SKB's handling of the regulatory review of the safety assessment SR-Can

This document describes how SKB has taken account of the outcome of the regulatory review of the safety assessment SR-Can. The review was reported in two identical documents issued by SKI and SSI, respectively; SKI Report 2008:23 and SSI Report 2008:04 E.

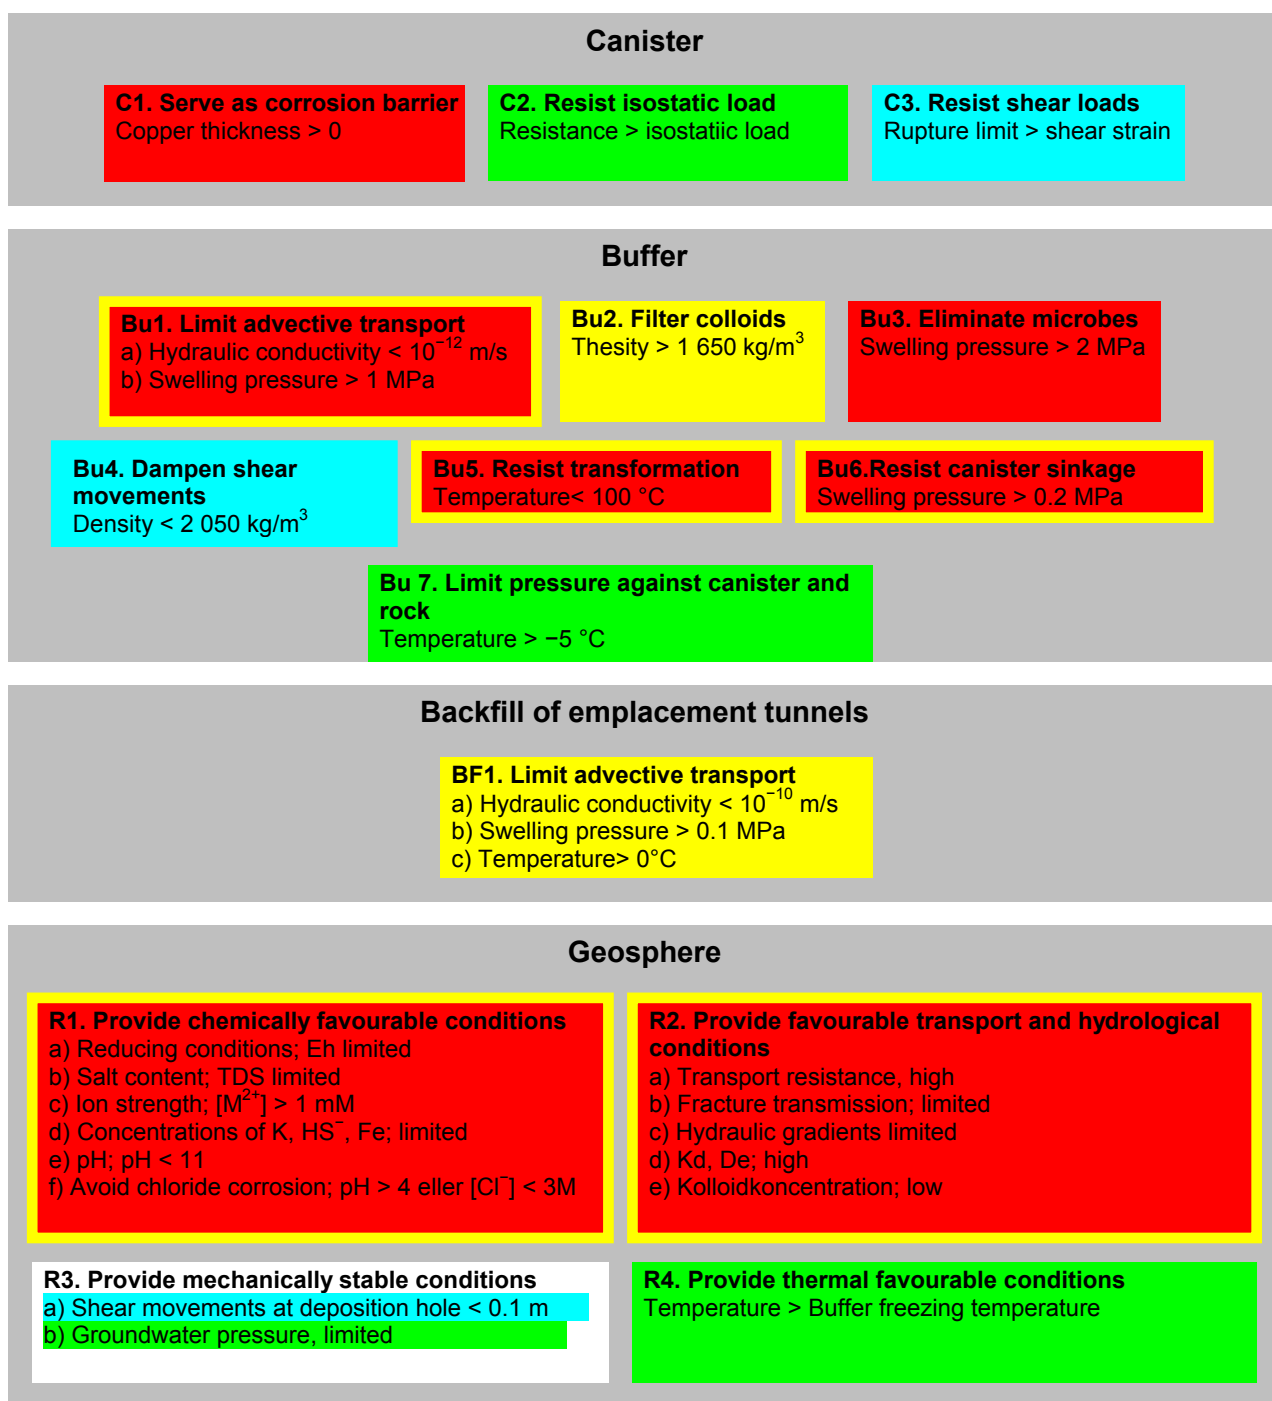
SAM considers that SKB should describe more explicitly how the different barriers contribute to the safety functions isolation and retardation. A report of this kind should include the relative importance of the barriers in different scenarios, and their importance to show that the repository system has a built-in reserve capacity. SAM considers that the analysis of the safety function indicators is a good complement to the analysis of radionuclide transport. However, a clearer description is needed of the

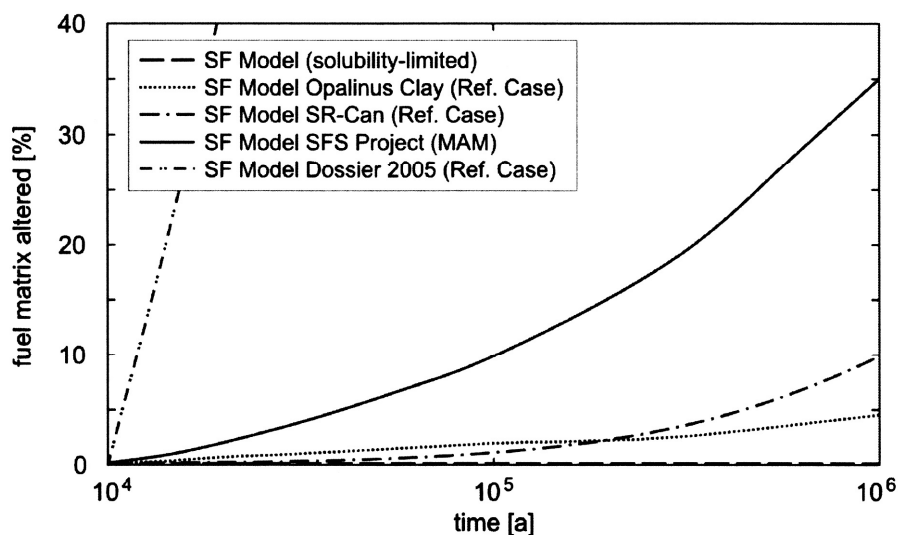
The authorities' consultants Stenhouse et al (2008) consider that SKB's proposed matrix dissolution rates are reasonable and realistic. However, it is pointed out in the review that the justification of the rate distribution and handling of uncertainties are weak. According to the consultants, there needs to be further evidence in addition to an extrapolation of experimental data to show that the chosen rates are valid for the whole time period that the safety assessment covers. The authorities' consultants suggest that available conceptual and mathematical models should be evaluated and utilised to a greater extent, including models produced within the framework of EU projects. EBS notes also the great importance of the fuel dissolution parameter and recommends additional work in this area.

The following figure show the resulting fuel dissolution versus time for these models as well as for a model assuming solubility-limited dissolution

In the longer perspective when the radiolysis is negligible, a solubility-limited dissolution seems to be the most realistic approach. In that perspective, the SR-Can model is pessimistic.
